SUBJECT: COMANCHE PEAK NUCLEAR POWER PLANT, UNITS 3 AND 4
DOCKET NUMBERS 52-034 AND 52-035
RESPONSES TO REQUESTS FOR ADDITIONAL INFORMATION
NO. 2883, 3127, 3193, 3219, AND 3559

Response to Request for Additional Information No. 2883 (CP RAI #64)

RAI NO.: 2883 (CP RAI #64)

SRP SECTION: 03.07.03 - Seismic Subsystem Analysis

Figure 1 Height from Bottom of Basin to Centroid of Impulsive Pressure Distribution (Excluding Base Effects) for 31 ft deep Basin considering Expressions from ACI 350.3-06 and TID-7024 (note ACI 350.03 is equal to or greater than TID-7024 for all values of Basin Length)

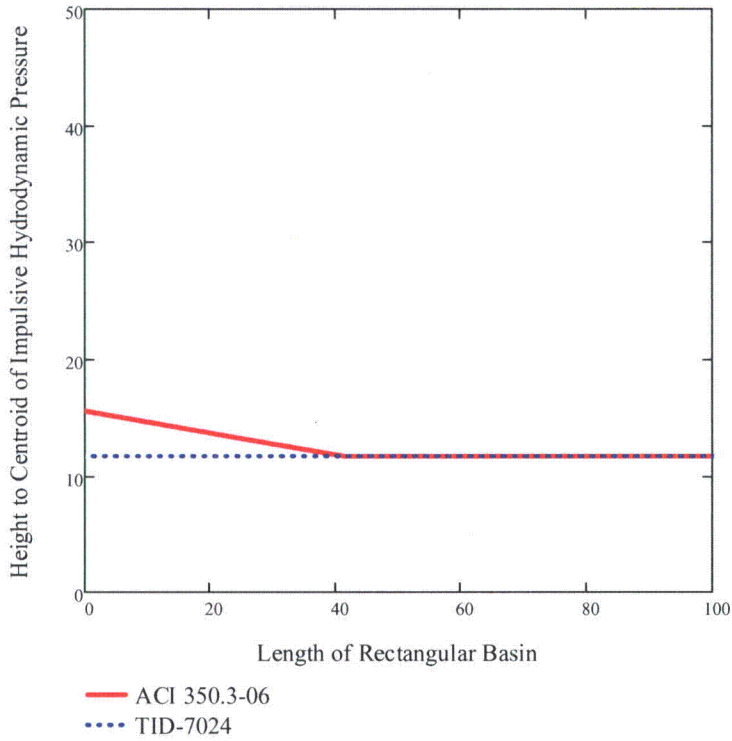
In combined license application (COLA), FSAR, Appendix 3KK (page 3KK-3), it is stated that the hydrodynamic effects of the water in the in the ultimate heat sink (UHS) structures is analyzed using the methodology of American Concrete Institute (ACI) 350.3-06. Describe the differences between the methodology of ACI 350.3-06 and the guidance provided in NUREG-0800 Standard Review Plan, (SRP) Section 3.7.3.II.14.A, and the references therein, and describe how the methodology used in the hydrodynamic analysis of the UHS basins differs from or complies with the SRP guidance.

NUREG-0800 SRP 3.7.3.II.14.A references ASCE 4-98, TID-7024, and NUREG/CR-1161 for acceptable techniques to assess hydrodynamic effects. ACI 350.3-06 was used for calculation of the hydrodynamic convective and impulsive masses, and associated heights and modeling was performed following the analysis procedures of ASCE 4-98. The procedures from ACI 350.3-06 used for design of the UHS are very similar or more conservative than the NUREG and associated documents as shown in the comparisons presented in Tables 1 and 2 and Figures 1 and 2 (attached). There is one part of Item F in Table 1 that was not included in the UHS hydrodynamic analysis. The omitted requirement is the influence of the vertical ground shaking on the lateral pressures on the basin walls. The increase in demands due to this omission is very small with no resulting impact on the adequacy of the design because it is accommodated by available margin.

Figure 1 Rectangular Hydrodynamic Regions used for Analysis

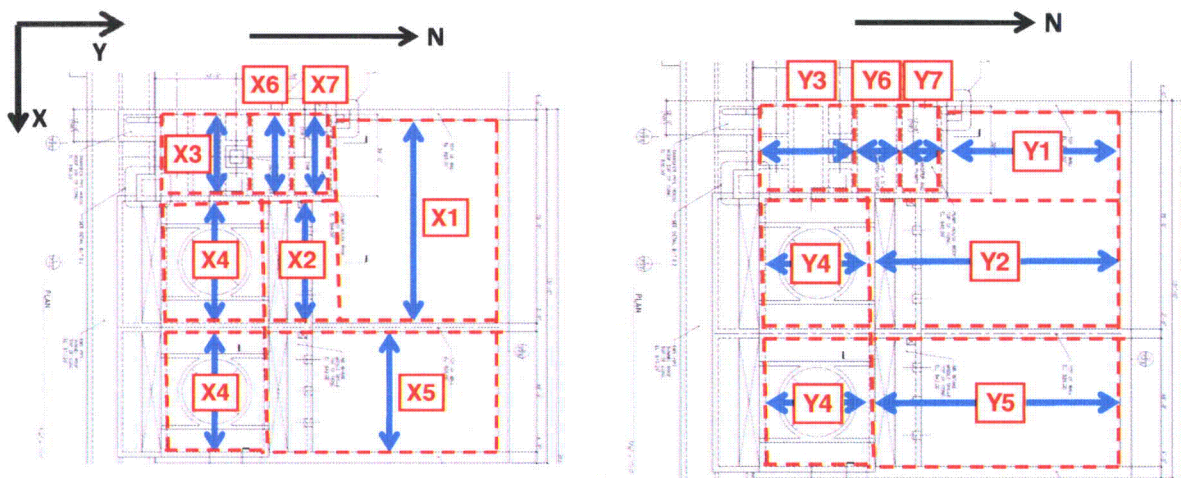
1. Clarification of how the convective mass of the water is treated in the analysis.
2. A description of each of the rectangular regions used in the analysis.
3. The convective frequencies for each of the regions.
4. The convective mass of the water for each of the regions.
5. The critical response parameters for the hydrodynamic analysis of the UHS basins.

The rectangular regions used for hydrodynamic calculations are shown in Figure 1. The regions were selected based on the clear dimensions of walls separating the basins, cooling tower cells, and pump room. Note the L-shaped region of basin 1 is separated differently for X- and Y-direction motion to adequately represent the conditions of a rectangular hydrodynamic region for which the expressions developed from ACI 350.3-06 or TID-7024 were derived.

Figure 3KK-4 Rectangular Hydrodynamic Regions Used for Analysis

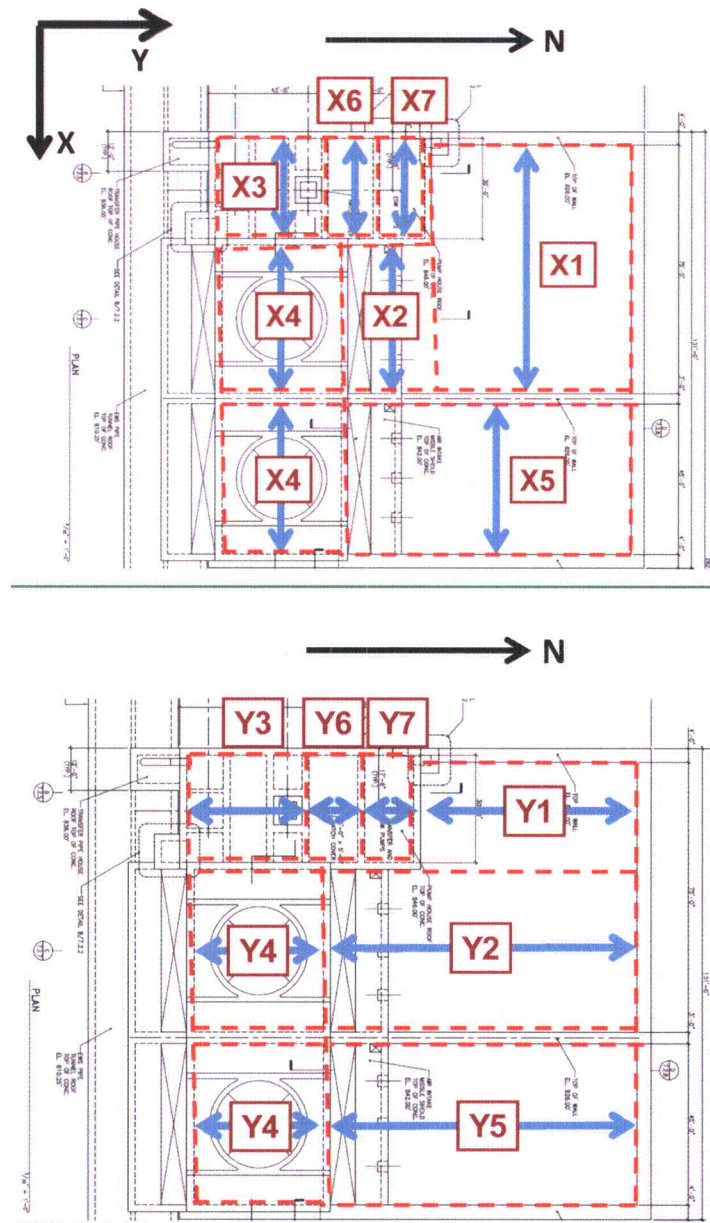
In COLA, FSAR Appendix 3KK (page 3KK-3), it is stated that the water within each rectangular region of the UHS structures is separated into impulsive and convective masses, but it is not required that the convective mass of the water in the UHS structures be modeled in the response spectra analysis to obtain seismic demands because the fundamental convective frequency is much lower than structural and soil frequencies.

The convective mass is included in the ANSYS response spectrum analysis using point masses and uni-directional springs. The mass is equal to the convective mass in Table 3KK-7 in the attached FSAR markup and the springs are assigned stiffness such that the mass-spring system has a frequency equal to the convective frequency in Table 3KK-7. Separate mass-spring systems are provided for all sloshing regions shown in Figure 1 below.
